ADDENDUM

GREENWICH BUSINESS PARK WASTEWATER PUMP STATION AND FORCE MAIN FOR LATERAL 136 WIS

WET WELL MOUNTED PUMP STATION GENSET PAD

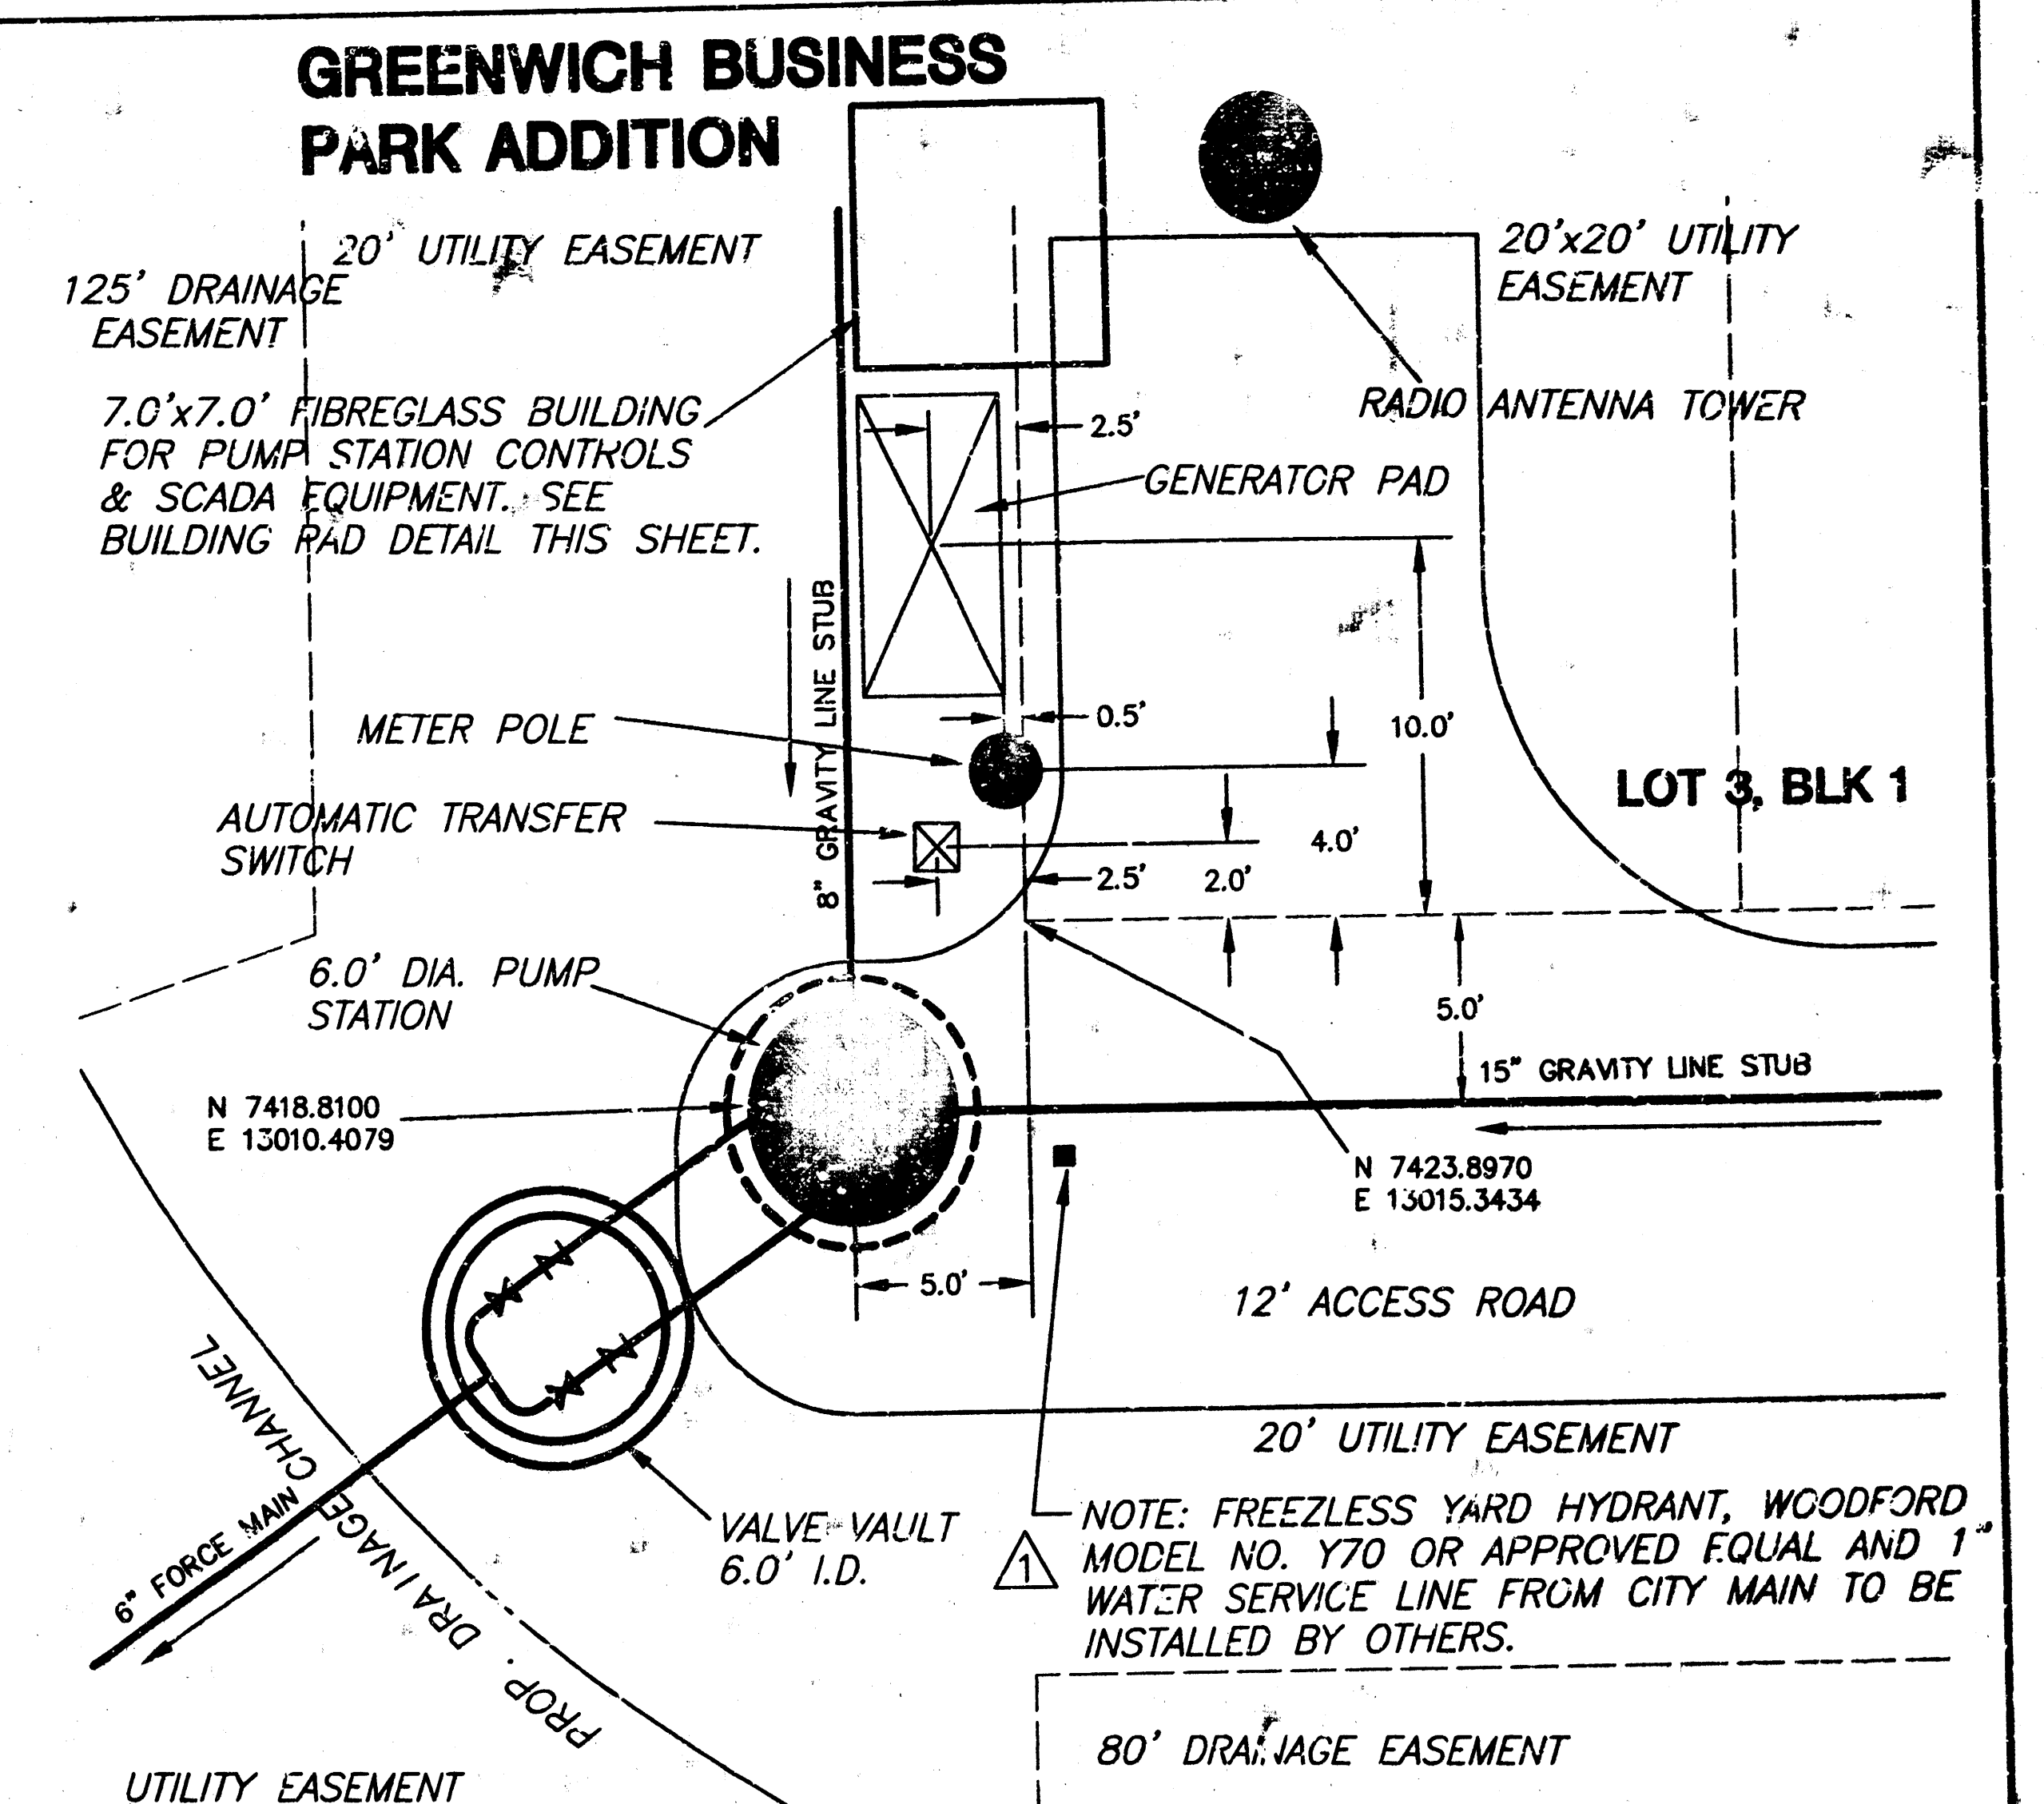
- CONTRACTOR SHALL COORDINATE ELEVATIONS OF FLOATS WITH LARRY KOONTZ (CITY OF WICHITA) 529-9900.
- CONTRACTOR SHALL INSTALL 2 POSTS AND A CHAIN FOR GATE AT ENTRANCE OF PUMP STATION ACCESS ROAD OFF OF 21st STREET NORTH. ALL COSTS FOR THIS WORK SHALL BE SUBSIDIARY TO PROJECT.
